**ADDENDUM #2**

**FRUITDALE ROAD AND MCGARIGLE ROAD IMPROVEMENTS AND SR 9  
PEDESTRIAN/BICYCLE SAFETY IMPROVEMENTS PROJECT**

*City of Sedro-Woolley Project No. 2009-PW-02  
Federal Aid Project Nos. ARRA-HPP-7390(001)  
& ARRA-STPE-0009(057)  
WSDOT Contract Nos. TA-3543 & TA-3340*

**April 28, 2009**

SHEET  
**C6.3**

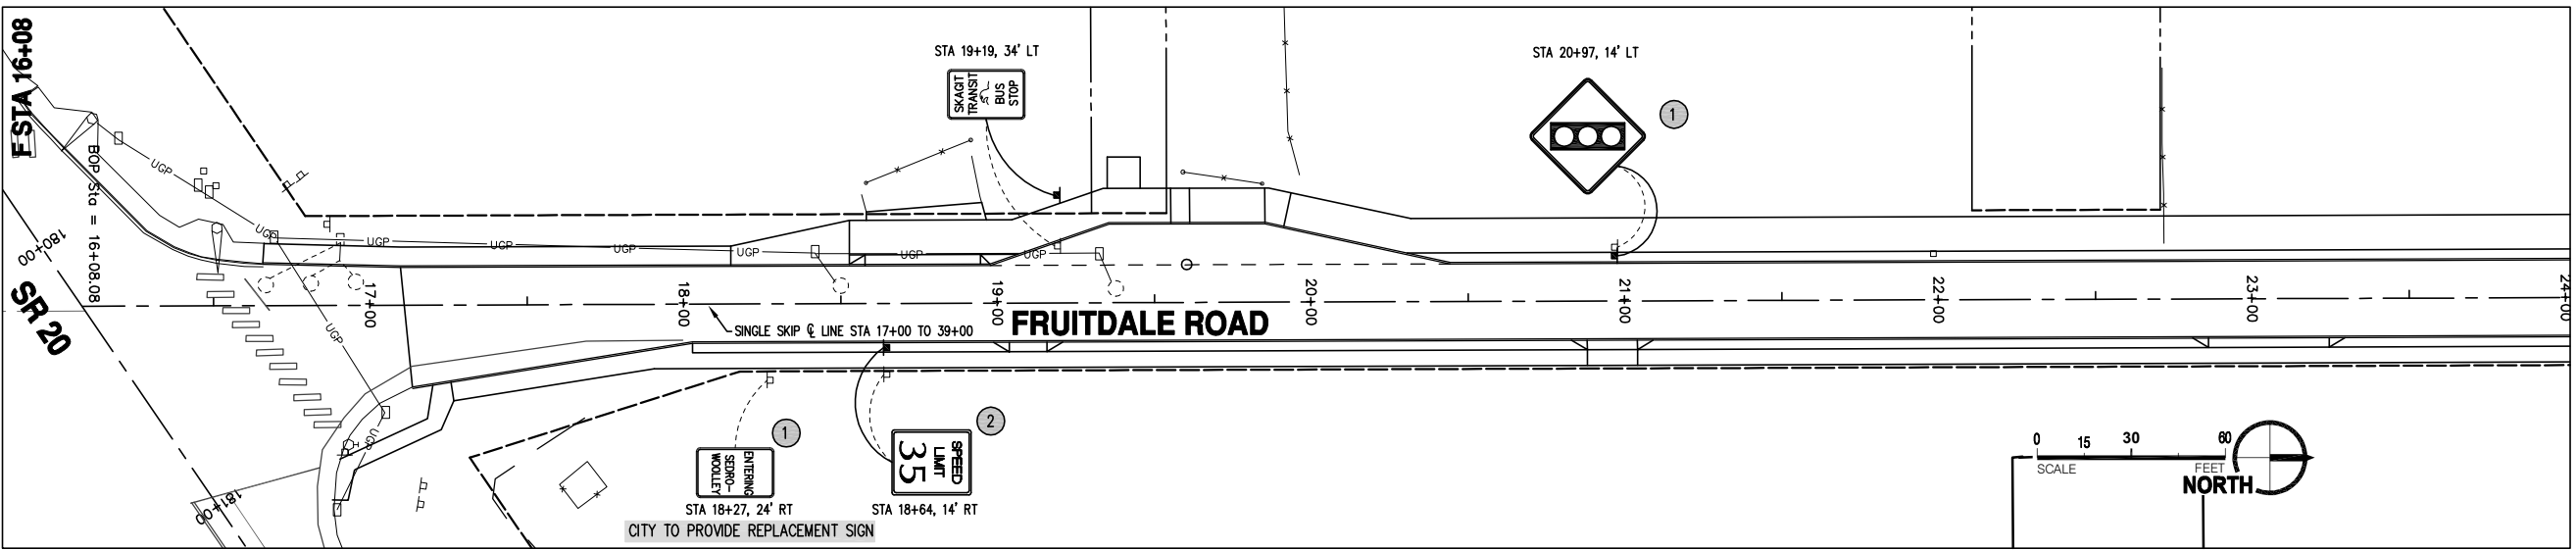
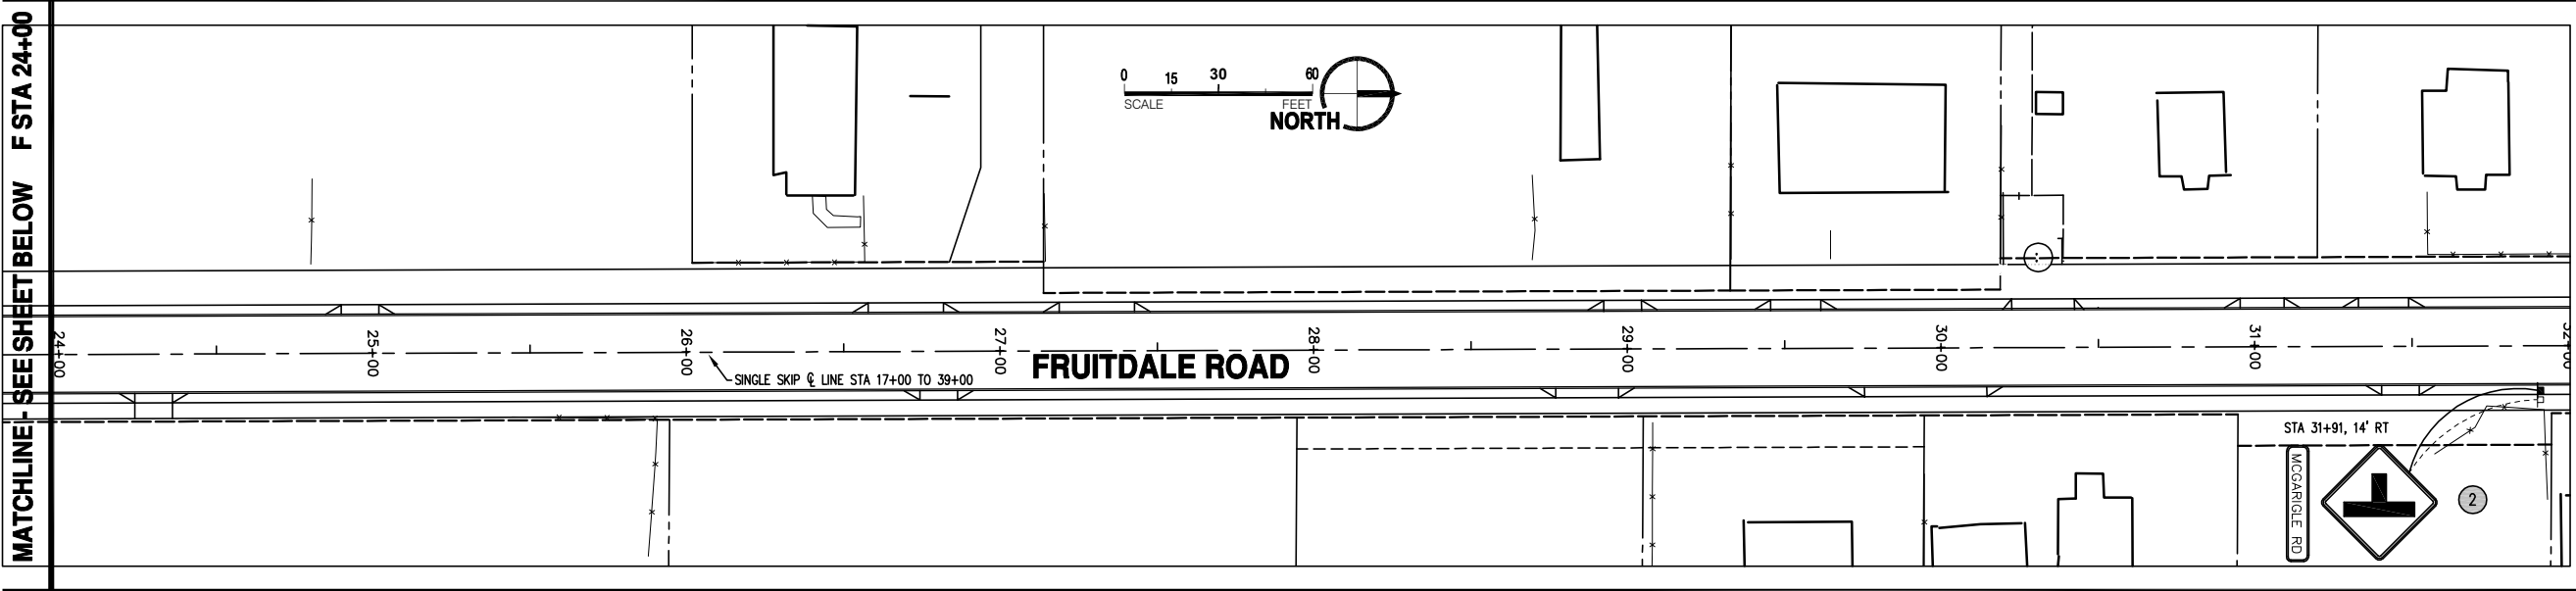
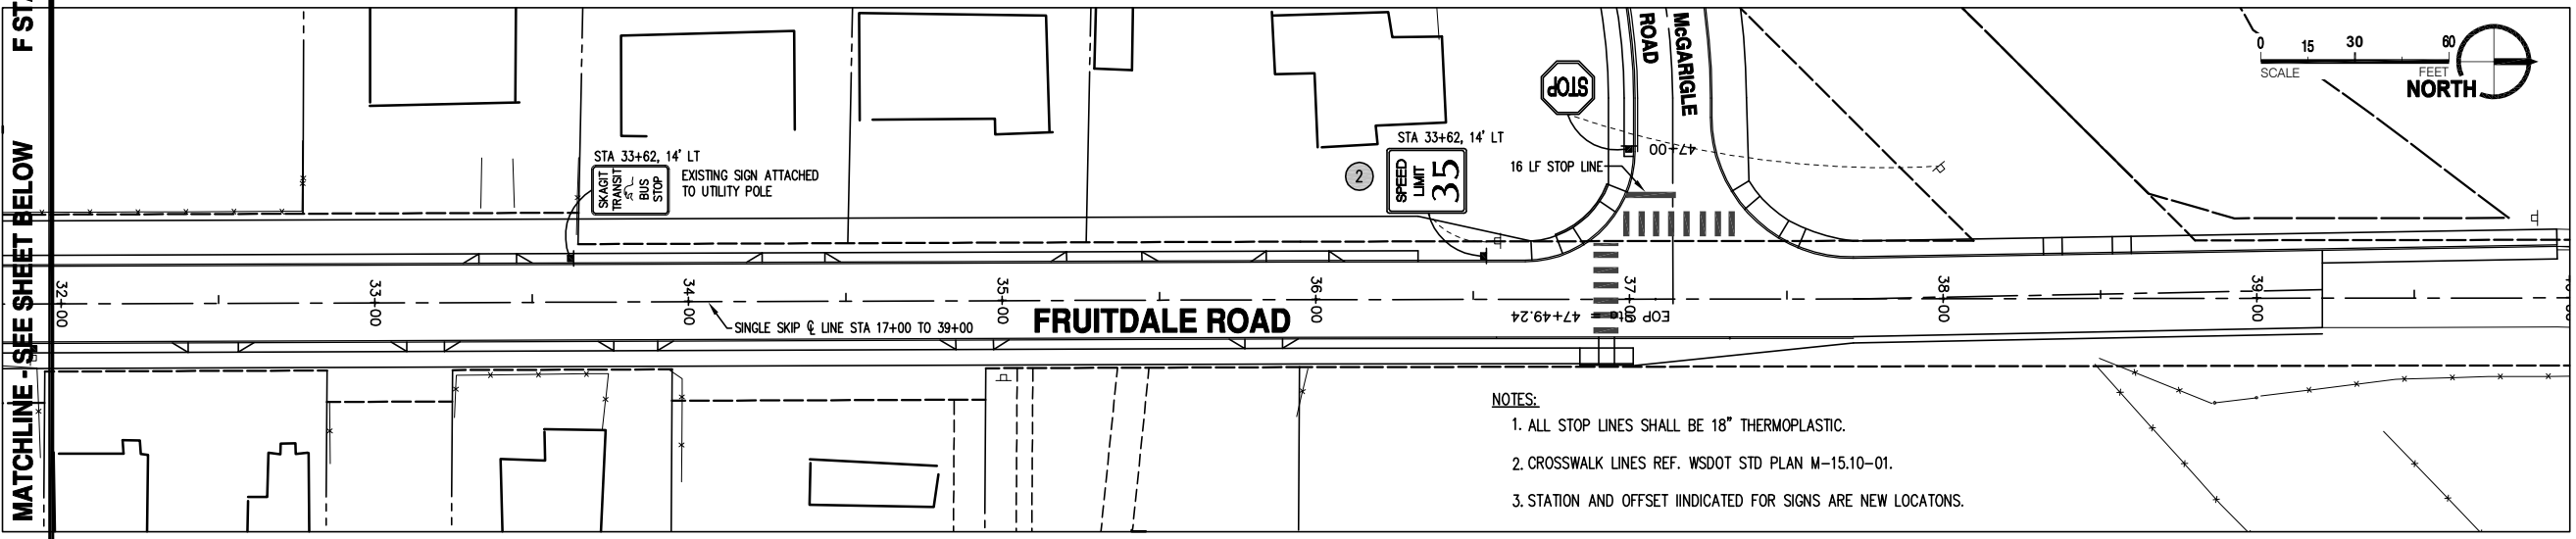
Replacement plan sheets for C6.1, C6.2 and C6.3 are issued with this addendum. Revisions include the replacement of signs to conform with the current MUTCD standards and the replacement of some wood posts with steel posts.

SK-NO.9

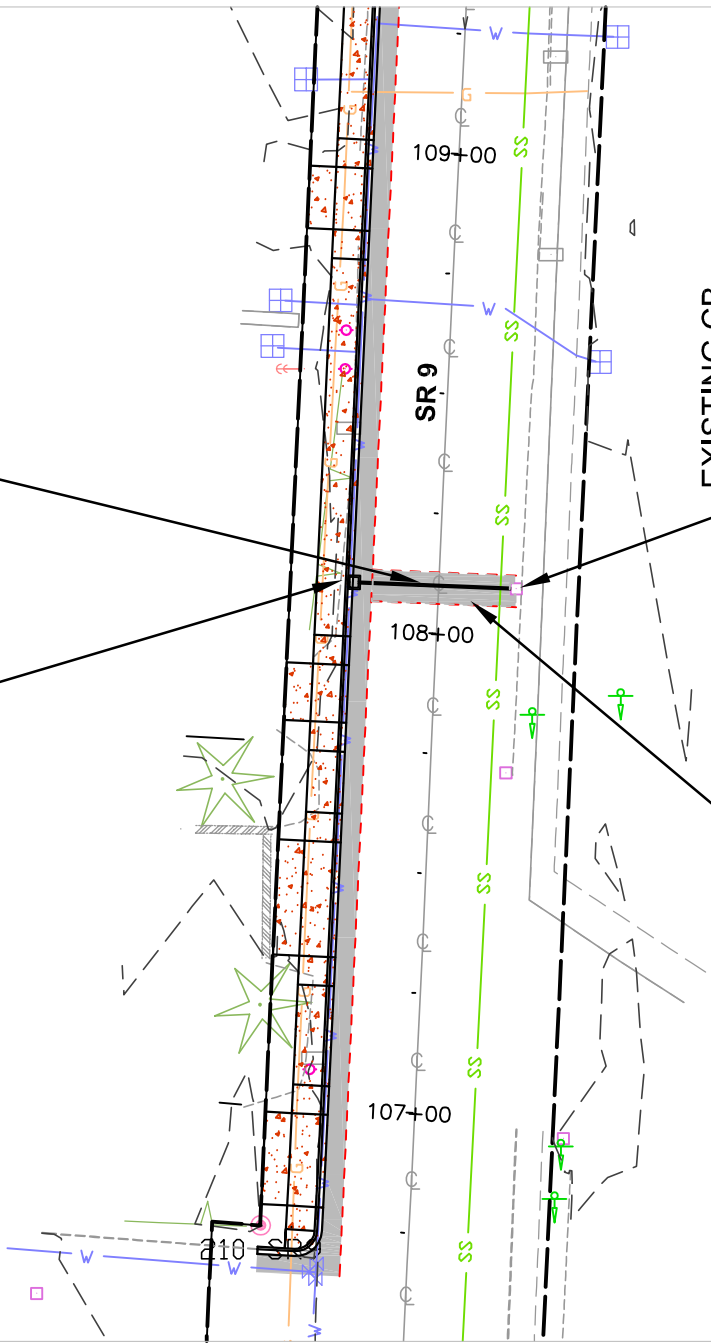
At STA 108+10 LT, a concrete inlet is ADDED with 35 LF 12" CPSSP at a slope of 0.005 ft/ft across SR 9 to connect to an existing catch basin. Refer to Addendum #2 sketch SK-NO.9. These quantities associated with this additional work were added to the revised Bid Schedules issued with Addendum #1.

STA 108+10, 17.2' LT  
 INSTALL CONC. INLET  
 BI-DIRECTIONAL VANED GRATE  
 TOP = 61.98  
 IE 12" CPSSP OUT E = 57.98

INSTALL 35 LF 12" CPSSP  
 SLOPE = 0.005 FT/FT TO  
 EXISTING CB

EXISTING CB  
 IE 12" CPSSP IN W = 57.80

TRENCH REPAIR PER  
 PLAN DETAILS.  
 MATCH EXISTING ASPHALT  
 THICKNESS (6" MIN.)
